# Exception Review Committee Public Hearing

Resource Protection Area (RPA) Encroachment Exception # 4135-WRPA-003-1 & Water Quality Impact Assessment # 4135-WQ-001-1

1932 Great Falls Street, McLean

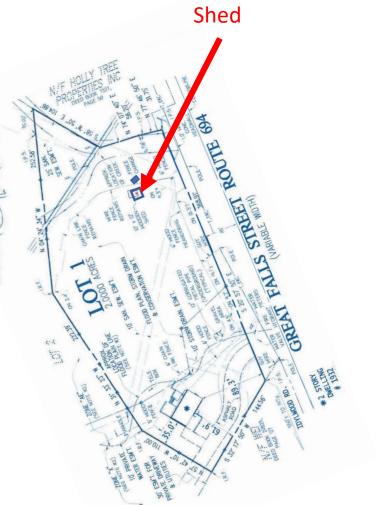
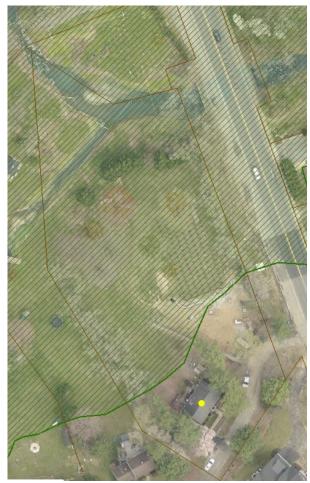
An exception is required under Article 6, Section 118-6-8.

- 756 sq. ft. of disturbance in the RPA
- 256 sq. ft. of total Impervious area (an increase of 136 sq. ft. from the footprint of the existing shed);
  - No impervious area in the seaward 50 feet.

Attachment D = RPA Buffer Area Planting

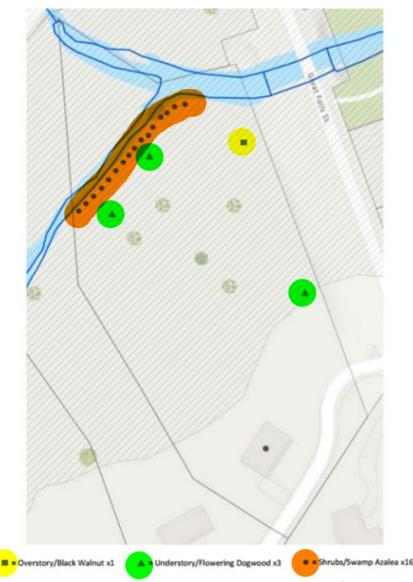
Finding 118-6-6.c The exception is in harmony with the purpose and intent of this Chapter and is not of substantial detriment to water quality.

- It is staff's recommendation that buffer mitigation be concentrated and planted in the lower portions of the site where runoff would be more effectively captured from the shed.
- The applicant has planted : 1 black walnut, 3
   dogwoods, and 16 swamp azaleas to mitigate the impact of the land disturbance.
- The plantings are taken from the recommended tree and shrub plant list for RPAs.

It is the opinion of Staff that the re-vegetated area should be concentrated and planted in the lower portions of the site.

1. The buffer plantings shall be planted in a focused area downslope of the proposed use to capture the runoff from the subject shed.
